Masco Industries Ltd Unit 2

12 December 2013

Building Observations Garment Factory

Columns appear to be stressed in excess of normal design limits

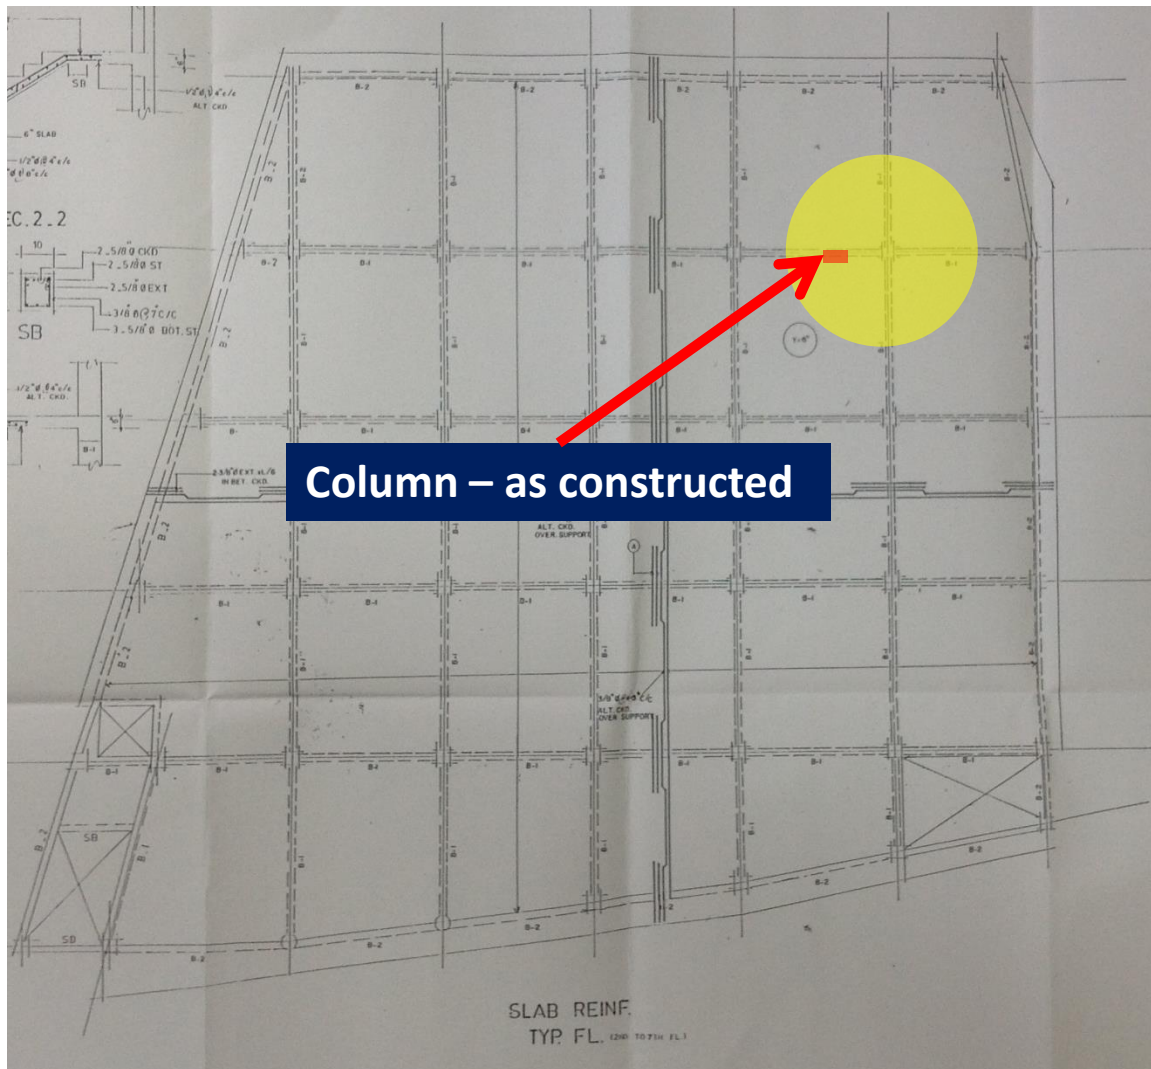
**Columns appear to be stressed in excess of
normal design limits**

Cursory calculations indicate that column size appears to be smaller than required by code for the applied dead and live load, assuming typical concrete strength

Building Engineer to perform detailed calculations and concrete tests to prove column size and (if required) :

- Reduce loads by preparation of allowable floor loading plans
- Carry out strengthening works

Column at South West of building

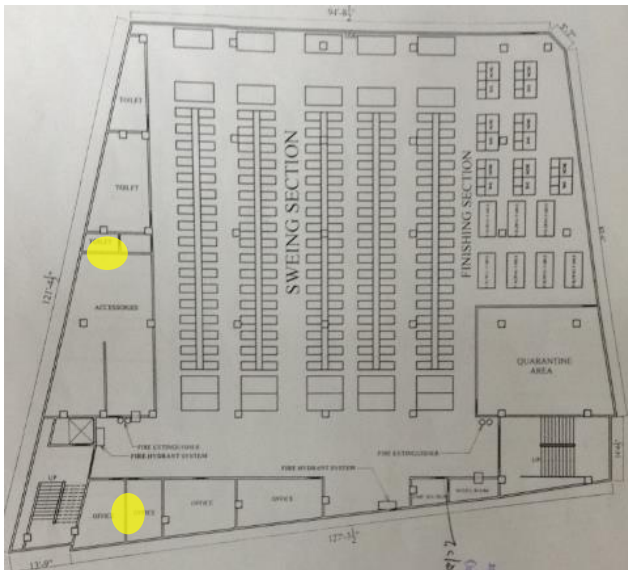
**Column at South West of building plan is not
constructed at the location shown on the
structural drawings**

The column is not constructed in the center of two beams

Item No.	Observation	Recommended Action Plan	Recommended Timeline
7	Garment Factory - Column at south west of building plan is not constructed at the location shown on the structural drawings	Building Engineer to survey column locations and compare with structural drawings to identify this and any other discrepancies in column locations between the design and as- built structure. (refer to item 1 – Detail Engineering Assessment)	6-weeks
8	Garment Factory - Column at south west of building plan is not constructed at the location shown on the structural drawings	Building Engineer to review the design calculations and confirm that the design corresponds with the as-built structure.	6-months
9	Garment Factory - Column at south west of building plan is not constructed at the location shown on the structural drawings	Layout and structural drawings to be updated	6-months
10	Garment Factory - Load management of storage loads on 2nd Floor	Produce and actively manage a loading plan for all floor plates within the factory giving consideration to floor capacity and column capacity. (Refer to Item 1)	6-weeks

Brick wall on 7th floor

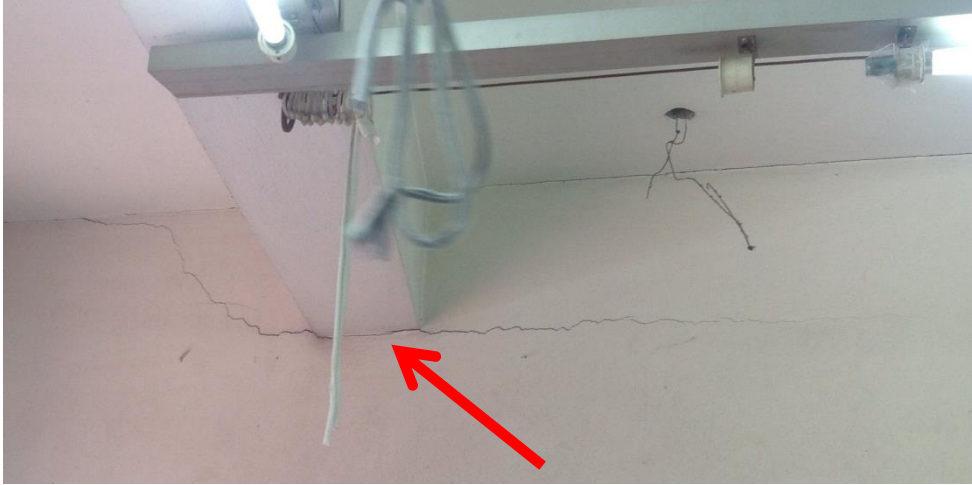
Cracking in internal brick wall on 7th and 5th floors at interface points with reinforced concrete beams above

Cracking in internal brick wall at points highlighted in yellow on 7th floor

11	Garment Factory - Load management of storage loads on 2nd Floor	Continue to implement load management plan	6-months
12	Garment Factory - Cracking in internal brick wall on 7th and 5th floors at interface points with reinforced concrete beams above	Sections of plaster finish to wall to be removed and extent of crack to be reviewed by Building Engineer	6-months

Item No.	Observation	Recommended Action Plan	Recommended Timeline
13	Garment Factory - Cracking in internal brick wall on 7th and 5th floors at interface points with reinforced concrete beams above	Building Engineer to confirm that wall and floor slab structure above act separately	6-months
14	Garment Factory - Cracking in internal brick wall on 7th and 5th floors at interface points with reinforced concrete beams above	Remedial works to be completed including isolation of structure from brick wall	6-months
15	Garment Factory - Cracking in internal brick wall on ground floor and 6th floor	Sections of plaster finish to wall to be removed, extent and cause of crack to be reviewed by Building Engineer	6-months
16	Garment Factory - Cracking in internal brick wall on ground floor and 6th floor	Remedial works to be completed including isolation of structure from brick wall	6-months
17	Garment Factory - Cracking to concrete beams and slabs on the underside of 4th, 5th, 6th, 7th and 8th floors	Sections of plaster finish to beams and slabs to be removed to investigate if cracks penetrate the building structure.	6-months

Brick wall on 6th floor

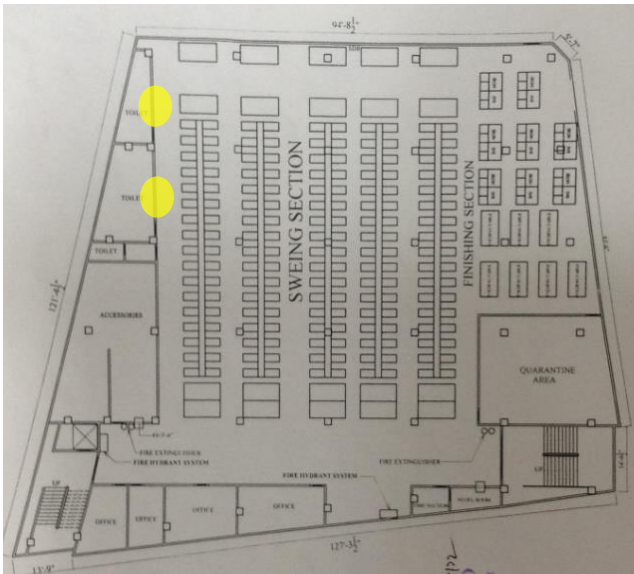
Cracking in internal brick wall on ground floor and 6th floor

**Cracking to internal brick wall
at points highlighted in yellow
on 6th floor**

Crack in slab – u/side 8th floor

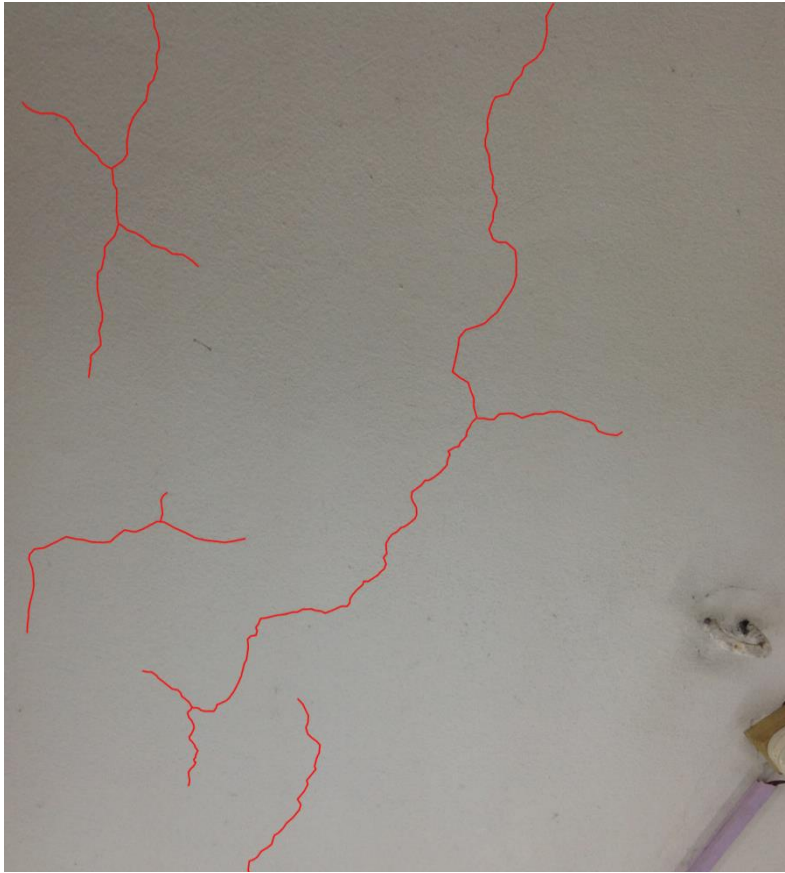
Cracking to concrete beams and slabs on the underside of 4th, 5th, 6th, 7th and 8th floors

18	Garment Factory - Cracking to concrete beams and slabs on the underside of 4th, 5th, 6th, 7th and 8th floors	Building Engineer to carry out design check on beams and slab to confirm that these cracks are non-structural. (refer to item 1 – Detail Engineering Assessment)	6-months

Crack in slab – u/side 5th floor

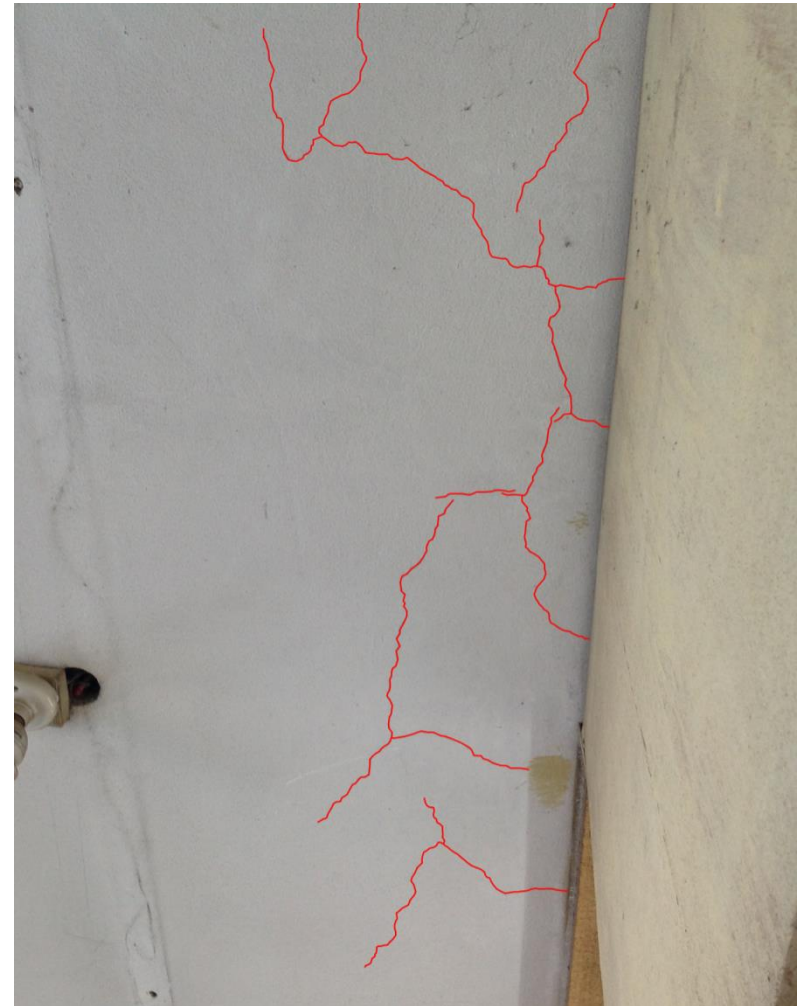
Cracking pattern similar to concrete slabs on the underside of 4th, 5th, 6th, 7th and 8th floor slabs

Crack in beams

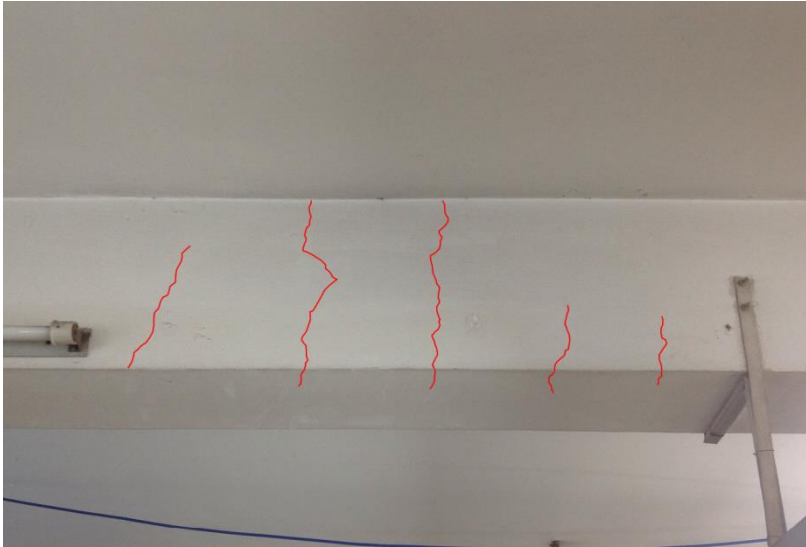
Crack in beam – u/side 4th floor

Crack in beam – u/side 8th floor

Cracking pattern to concrete beams on the underside of 4th, 5th, 6th, 7th and 8th floor slabs
